**Site: 20 Prospect Street**

**Case #:** PB 2019-06

**Date:** July 11 **August 14**, 2019

## STAFF REPORT

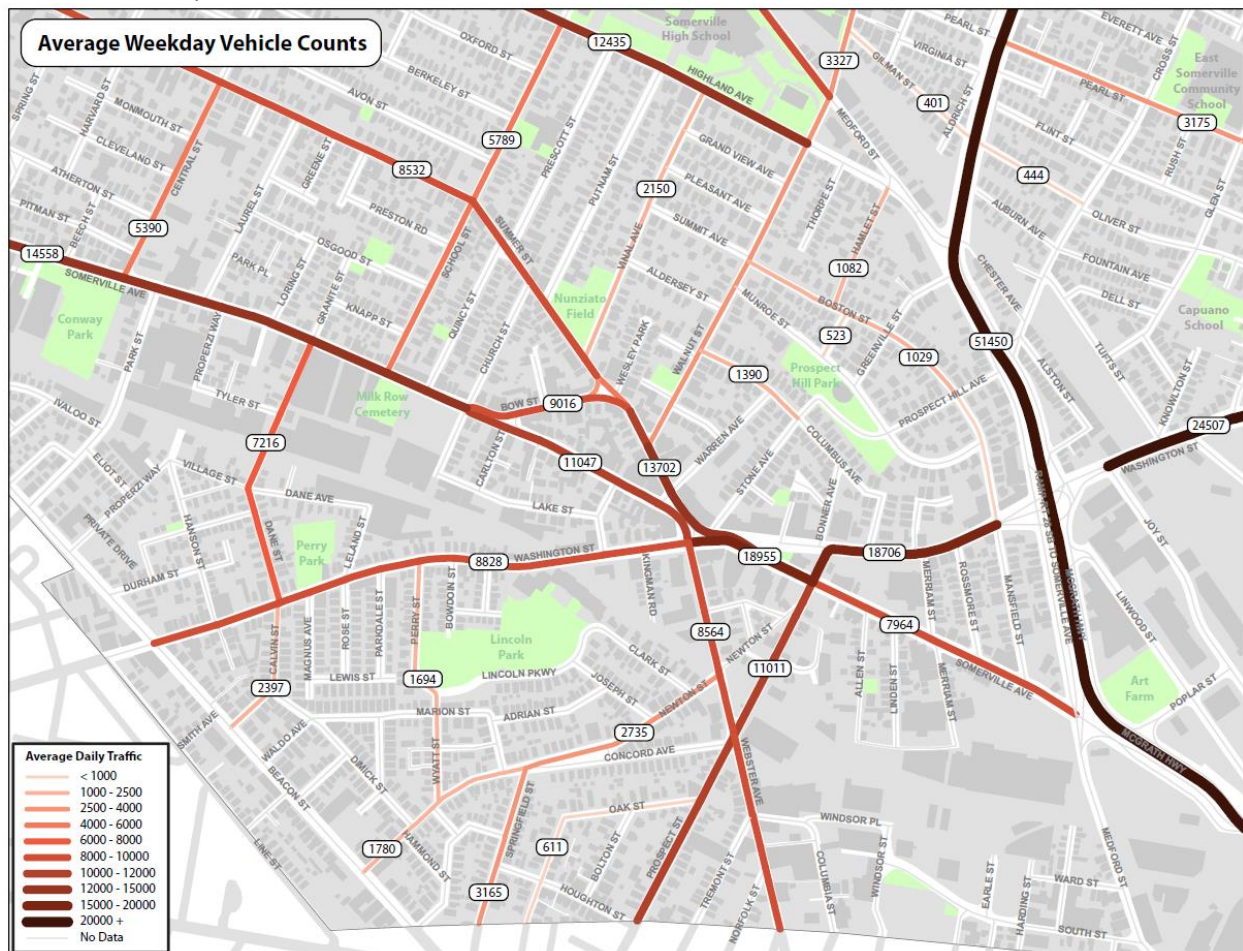
Single unit box trucks are able to enter and exit the alley system at Bennett Court or Milk Alley with little interference to opposing traffic on Prospect Street and Somerville Avenue and can easily reverse maneuver into the loading dock.

Tractor semi-trailer trucks are able to enter the alley system without crossing into oncoming traffic lanes by making a left turn into Milk Alley from Somerville Avenue when traveling west, a right turn into Bennett Court when traveling north on Prospect Street, and a left turn into Bennett Court when traveling south on Prospect Street. Turning right into Milk Alley when traveling east on Somerville Avenue requires a WB-40 truck to infringe both the west-bound travel and turning lanes of Somerville Avenue. To enter the loading dock of D2.2 from southbound travel on Milk Alley requires the WB-40 type truck to make a complex four-point turn to reverse direction using Bennett Court. To enter the loading dock from Bennett Court requires a less complex reverse maneuver into the loading dock.

When exiting the loading dock, a WB-40 truck type will have to turn left and exit the alley system via Milk Alley onto Somerville Avenue. Regardless of exiting direction, this truck type will infringe on traffic movements in opposing lanes temporarily.

### Pedestrian Level Wind Analysis

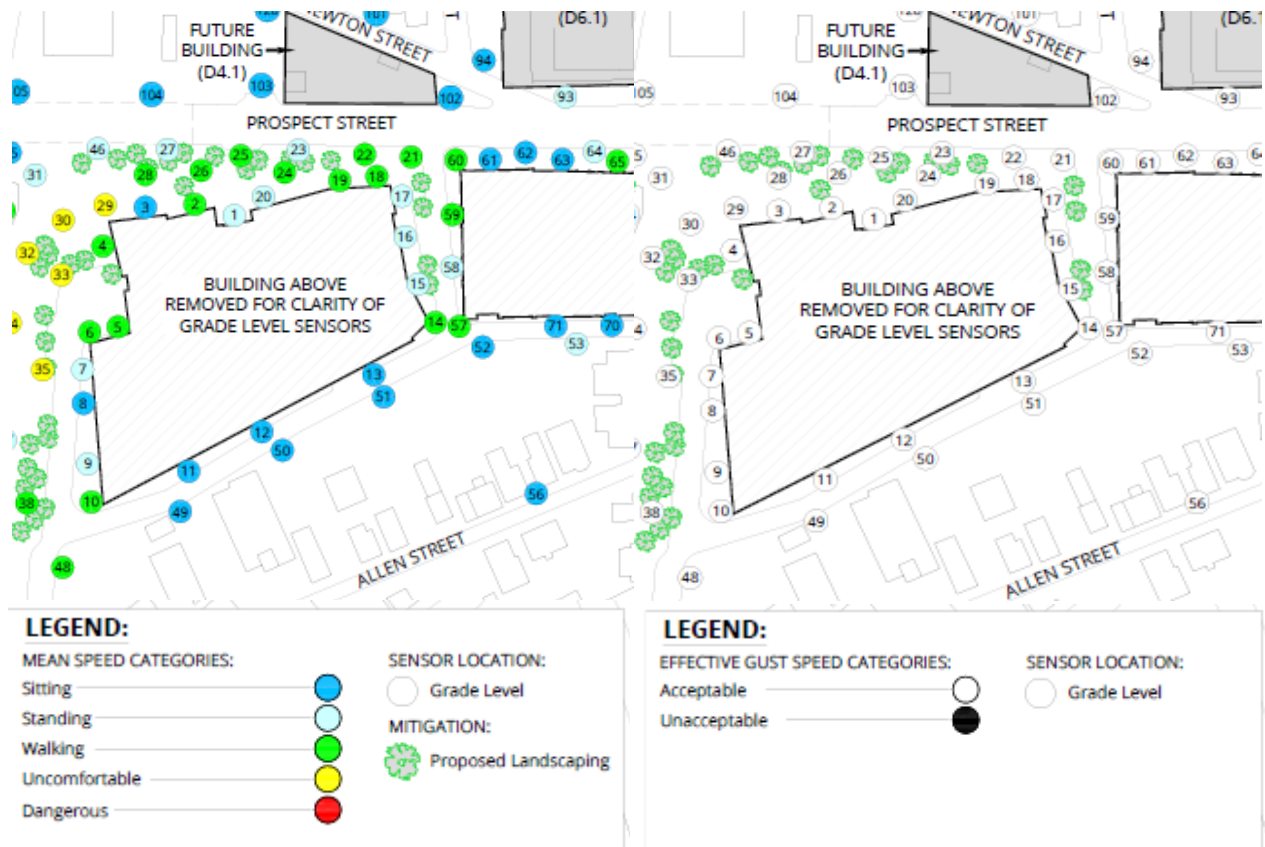
The Applicant submitted a pedestrian level wind study prepared by Rowan Williams Davies & Irwin Inc. The City requires a wind analysis to determine the suitability of various locations for various activities (e.g., walking, sitting, standing, etc.) and requires that mean wind speed and effective gust speeds not be exceeded for particular activities more than one percent (1%) of the time without mitigation. Wind statistics recorded at Boston Logan International Airport are used to estimate wind characteristics for the D2 site. The development of D2.2 is not specifically called out as increasing wind speeds.
